Subject: Notice of Availability SEIR - Ravenswood Business District/4 Corners Specific Plan Update, City of East Palo Alto

The City of East Palo Alto, as the Lead Agency, prepared a Subsequent Environmental Impact Report (SEIR) in accordance with the California Environmental Act (CEQA) for the Ravenswood Business District/4 Corners Specific Plan Update. Please see the attached document in English and Spanish for more details.

From: [Wu, Elton H](#)
To: [RBD](#)
Cc: [Read, Emily](#); [Feng, Stacie](#); [Leung, Tracy](#); [RES](#); [Wilson, Joanne](#)
Subject: Ravenswood Business District/4 Corners Specific Plan Update SEIR- SFPUC Public Notice Response
Date: Monday, July 29, 2024 1:52:14 PM
Attachments: [SFPUC Comments Via Email JWilson 5-16-2022.msg](#)

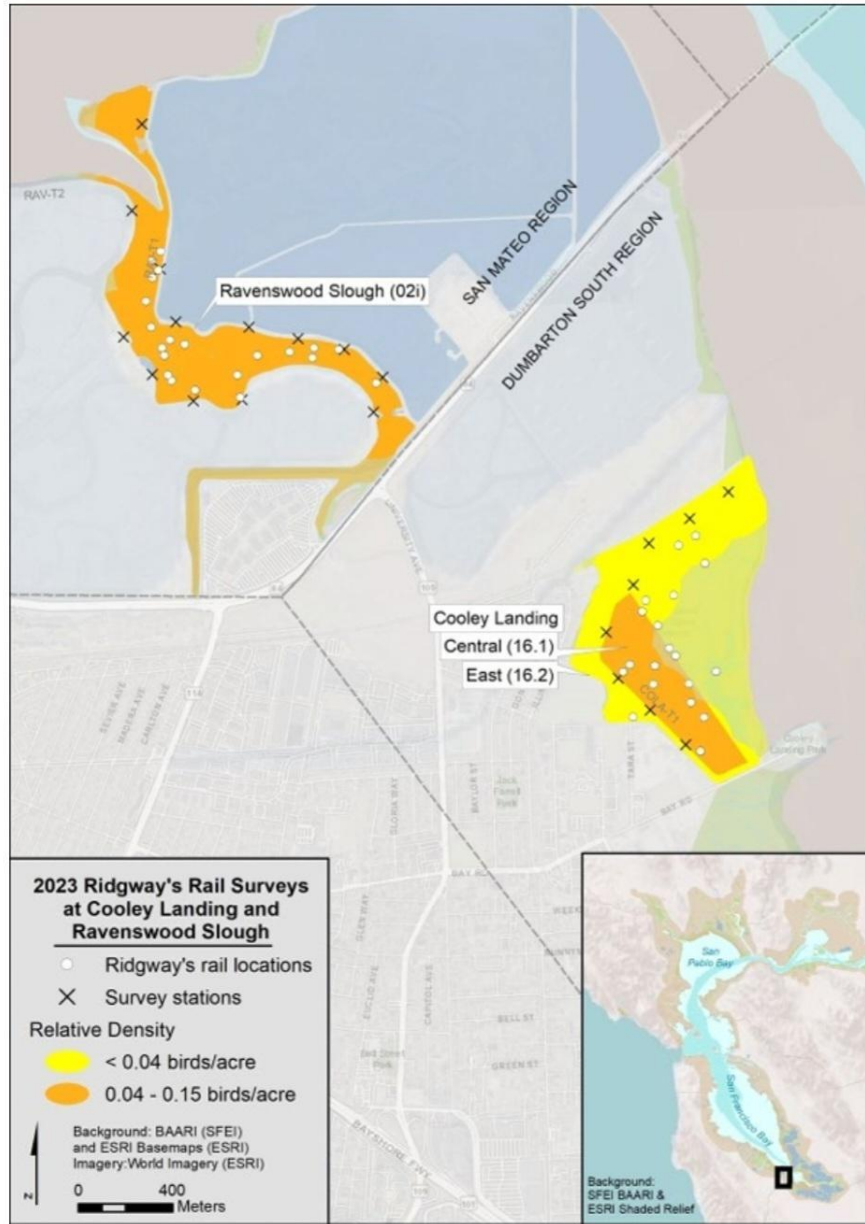
"Occurrence in Ravenswood/4 Corners": This table identifies lands within the RBD Area and adjoining the northeast part of the project that are known habitat for California Ridgway's rails (RIRA).

Recommendation: *Please also describe marshes between Cooley Landing and Runnymede Street, the Laumeister Marsh, a unit of the Don Edwards National Wildlife Refuge. 2023 survey report data maps a substantial number of these rails in the Ravenswood Open Space Preserve.⁹ Like surveys were not performed in the Refuge's Laumeister Marsh for that report but, by proximity and historical surveys, it is highly likely that Ridgway's rails use that marsh as well.*

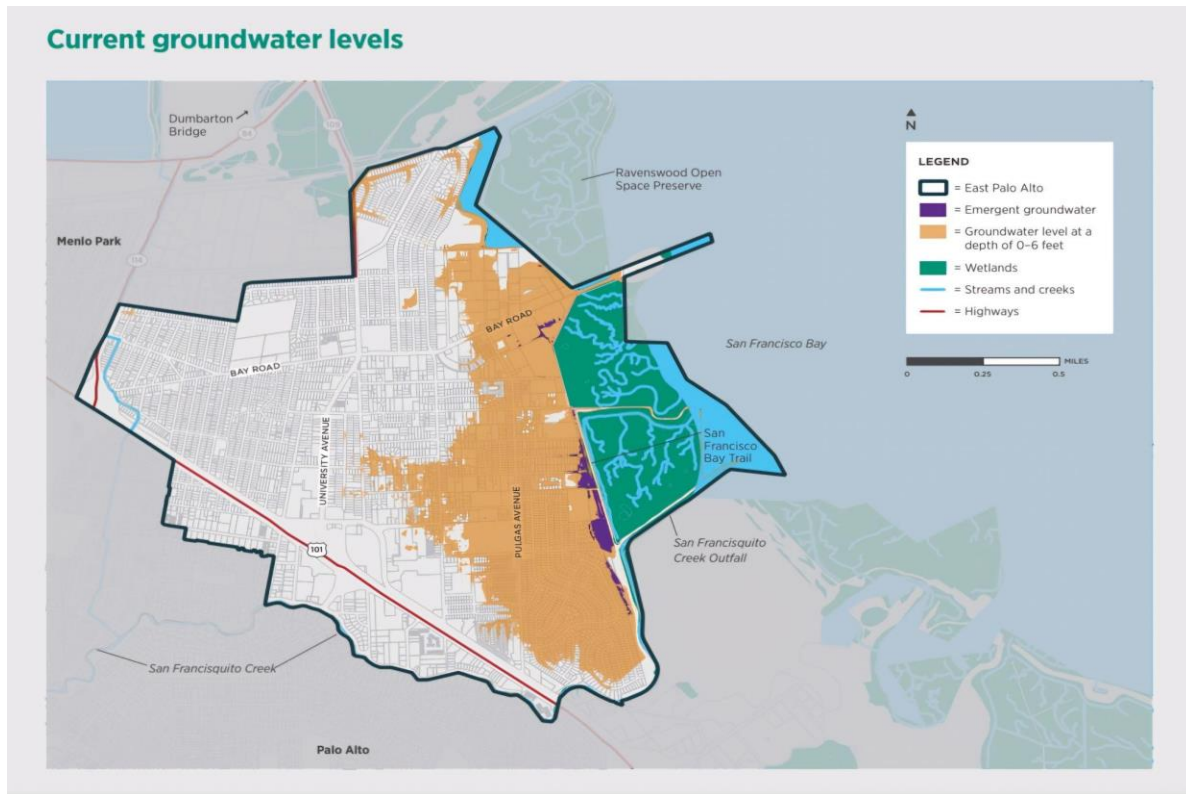
Section 3.10 Groundwater discussion focuses on recharge of groundwater and notes that historical groundwater levels vary from zero to 10 feet below existing grade, citing California Geological Survey data from 2006. The discussion omits more recent data such as was the

basis for the report, Look Out Below,³² a case study built on recent, substantial, and local scientific studies³³ that provided data specific to East Palo Alto. In it, maps displayed large areas of East Palo Alto and the SP Area with groundwater levels either at zero to six feet below grade or emergent. These areas lay along the shoreline, extend substantially inland and have underground flow adjacency with non-SPU areas. The Look Out Below map seen here includes an isolated zero to six feet site along University Avenue near 4 Corners.

While 9.7-6, as proposed, is limited to shoreline properties, recent data demonstrate that shallow groundwater impacts apply much more broadly in the SP Area. As shallow groundwater areas connect across project and Specific Plan boundaries, a development action in one location, such as a below-ground garage, can redirect subsurface water onto other parcels or the Bay, impacting conditions on those sites.

Recommendation: *DSPU Standard 9.7.6 should be amended to apply area-wide and flooding should be added to the impacts articulated in the Standard. Additionally, like DSPU Policy LU-6.4, Standard 9.7.6 should be incorporated throughout the SEIR's Land Use and Planning Impact Discussion, Section 3.11.2, and Non-CEQA Effects discussion, Section 3.11.3.*

Figure 5

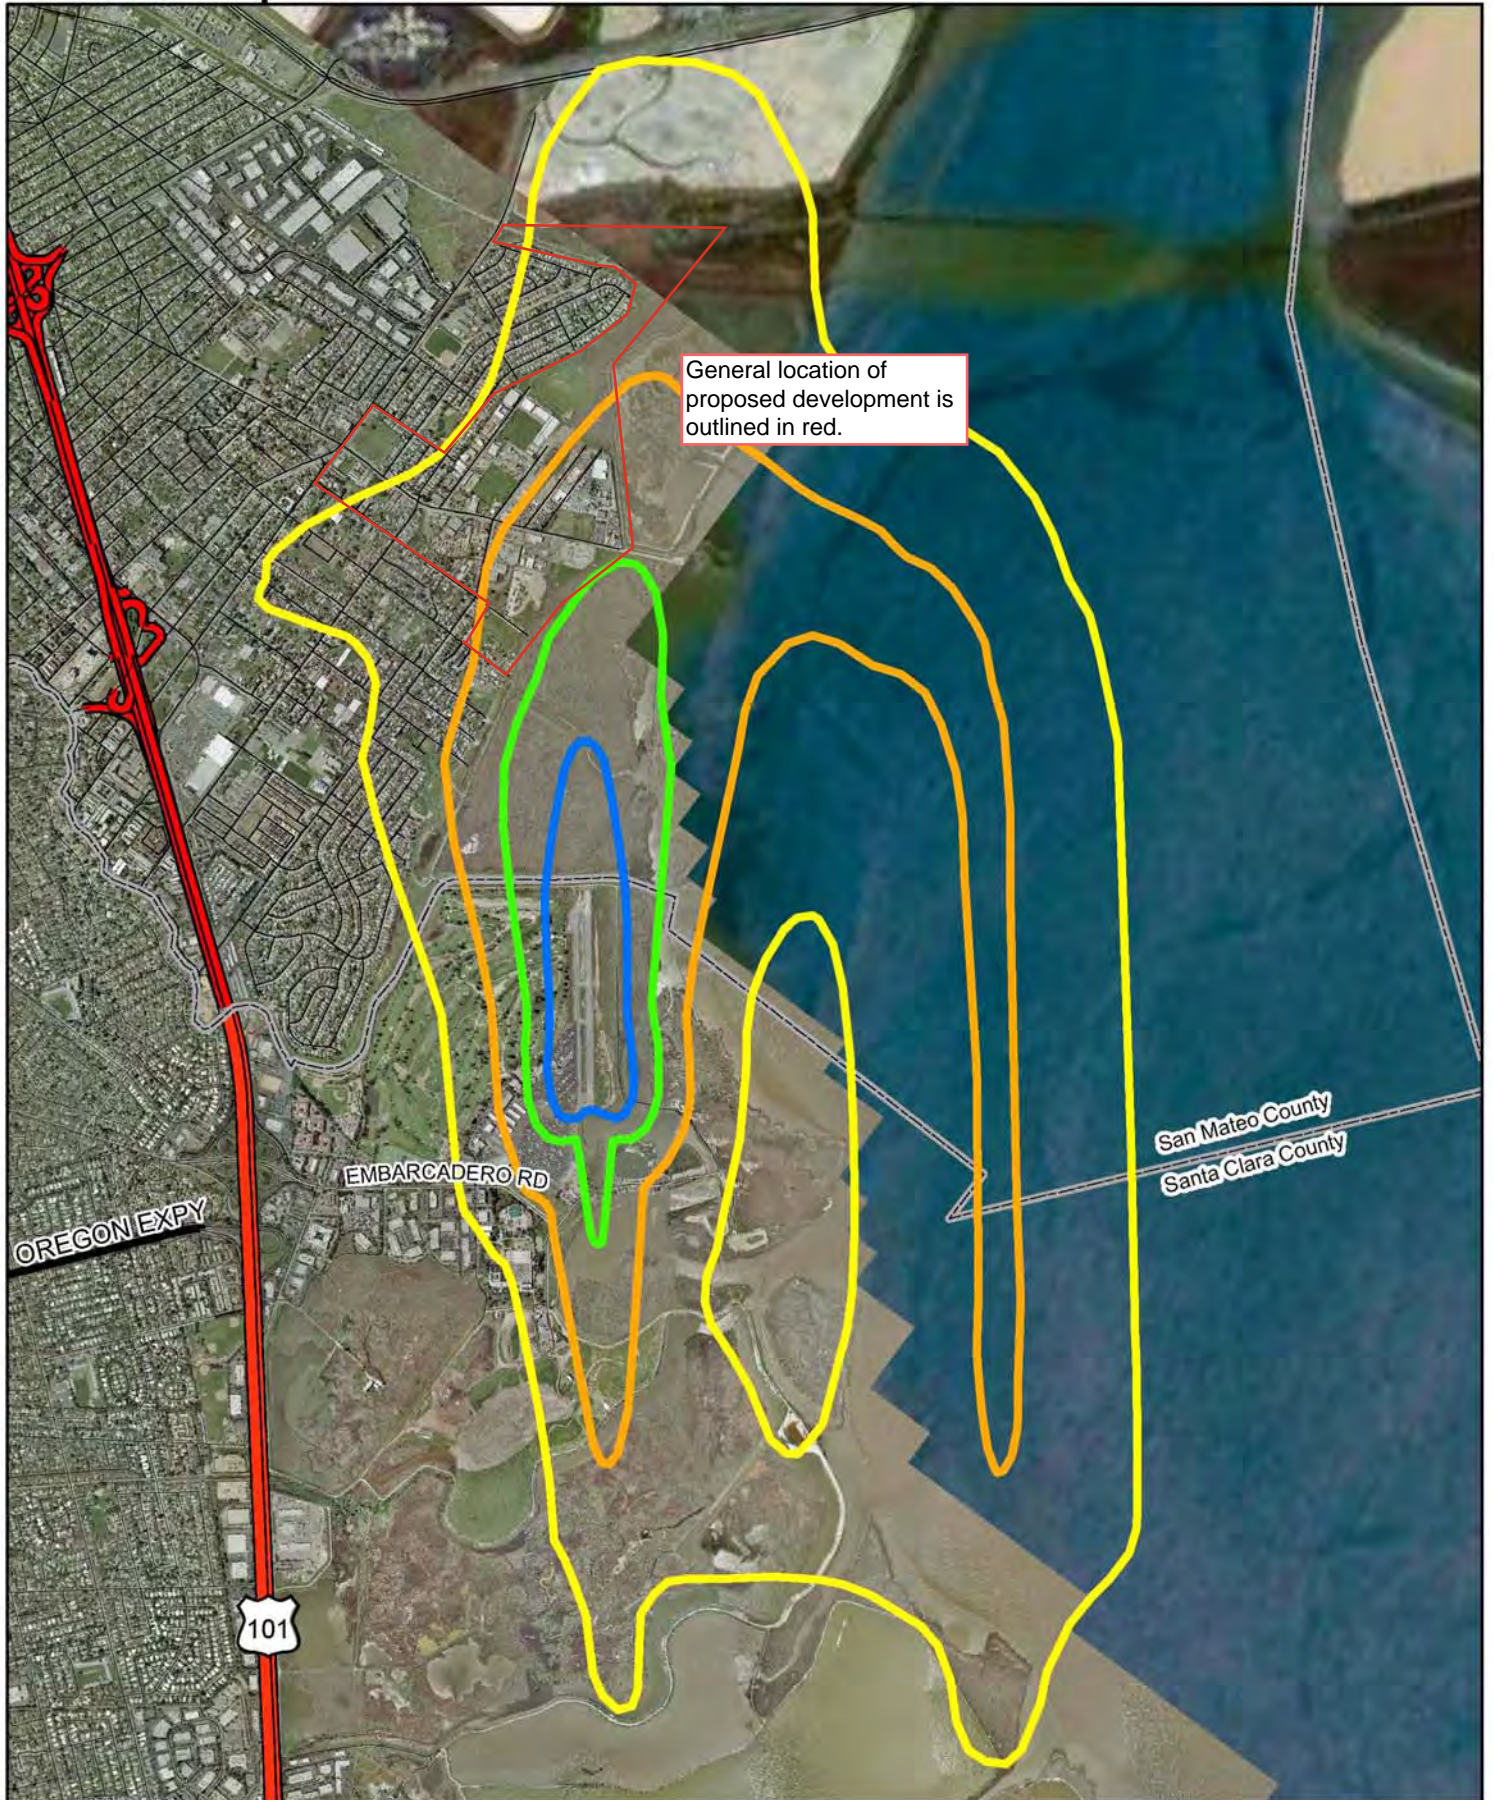
- In reviewing Figures 2.3.1 (proposed land uses) and 2.3.2 (existing land uses) of the Draft EIR, the project proposes to increase residential uses/density within the 60 and 65 CNEL contours of the Palo Alto Airport Influence Area. The Draft EIR does not properly disclose, and therefore does not identify appropriate mitigation, to address impacts related to the development of residential uses within the AIA and specifically within these contours, consistent with the policies set forth in the Palo Alto Airport Comprehensive Land Use Plan (CLUP). Please refer to the attached CLUP Figure 5 for the airports' Aircraft Noise Contours.

- *N-5 Residential construction will not be permitted in the area between the 60 dB CNEL contour boundary and the 65 dB CNEL contour boundary unless it can be demonstrated that the resulting interior sound level will be no greater than 45 dB CNEL.*

Due to the proximity of the Plan area to the Palo Alto Airport, the SEIR should anticipate that future residents will experience aircraft noise in the area. To prevent this project from expanding the airport's noise impact area, each residential unit shall grant the airport an aviation easement, permitting aircraft noise over the property.
